8. Well Name and No.
MODELO 10 FED COM 201H

EOG Resources requests an amendment to our approved APD for this well to reflect a change to a 4-string casing design and the addition of a pilot hole.

EOG RESOURCES, INC.
MODELO 10 FED COM NO. 201H

PECOS DISTRICT DRILLING CONDITIONS OF APPROVAL

Exhibit 1

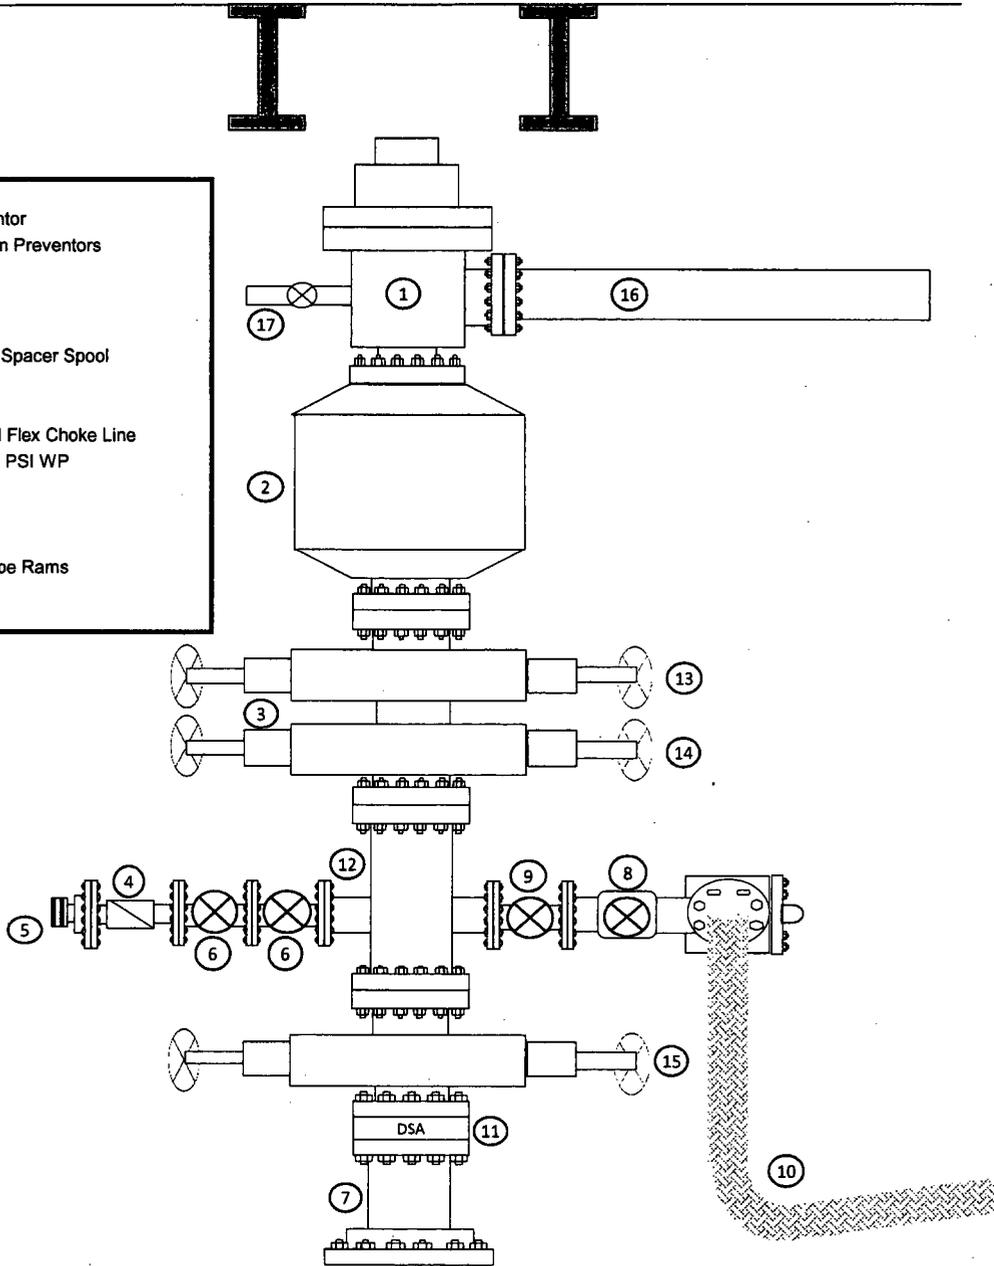
Variance is requested to use a co-flex line between the BOP and choke manifold (instead of using a 4" OD steel line).

The minimum blowout preventer equipment (BOPE) shown in Exhibit #1 will consist of a single ram, mud cross and double ram-type (10,000 psi WP) preventer and an annular preventer (10,000-psi WP). Both units will be hydraulically operated and the ram-type will be equipped with blind rams on bottom and drill pipe rams on top. All BOPE will be tested in accordance with Onshore Oil & Gas order No. 2.

Variance is requested to use a 5,000 psi annular BOP with the 10,000 psi BOP stack.

1. Variance approved to use flex line from BOP to choke manifold. Manufacturer's specification to be readily available. No external damage to flex line. Flex line to be installed as straight as possible (no hard bends).
2. Minimum working pressure of the blowout preventer (BOP) and related equipment (BOPE) required for drilling below the surface casing shoe shall be **5000 (5M) psi.**

Variance approved to use a 5M annular. The annular must be tested to full working pressure (5000 psi.)

EOG Resources 13-5/8" 10M PSI BOP Stack

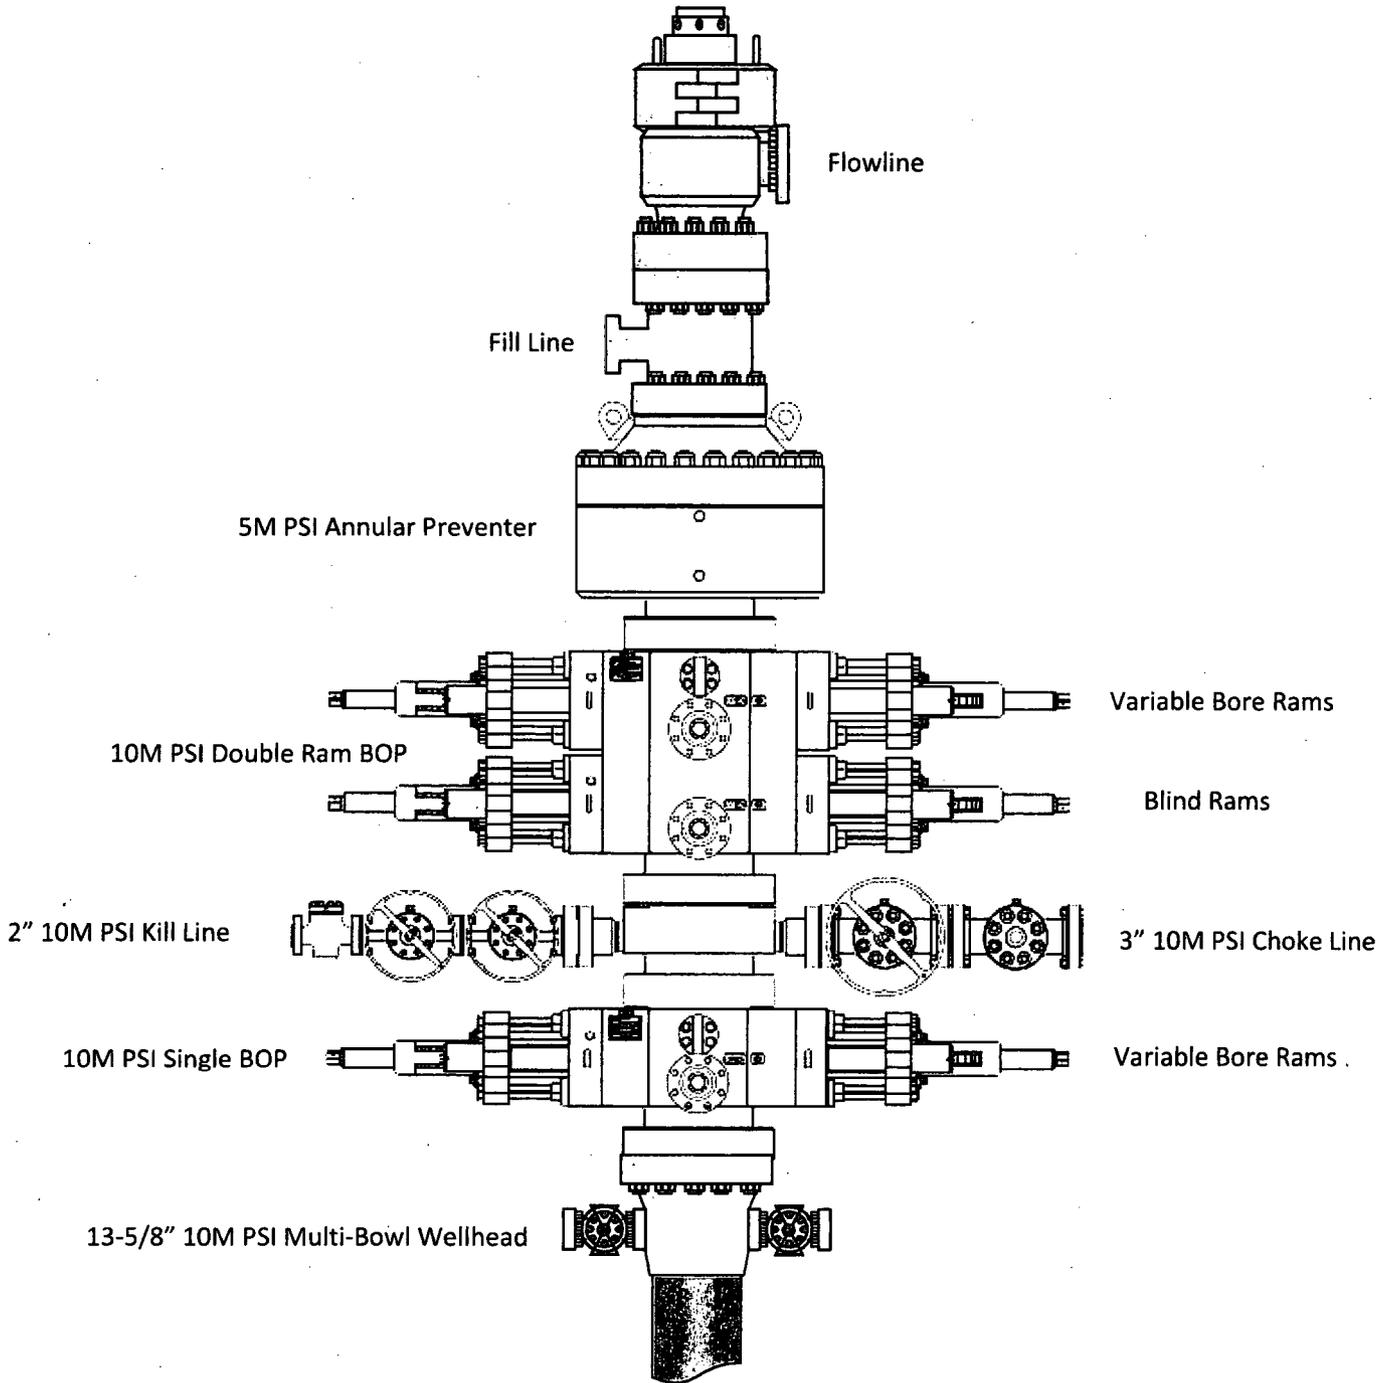
10,000 PSI BOP Annular Variance Request

EOG Resources request a variance to use a 5000 psi annular BOP with a 10,000 psi BOP stack. The component and compatibility tables along with the general well control plans demonstrate how the 5000 psi annular BOP will be protected from pressures that exceed its rated working pressure (RWP). The pressure at which the control of the wellbore is transferred from the annular preventer to another available preventer will not exceed 3500 psi (70% of the RWP of the 5000 psi annular BOP).
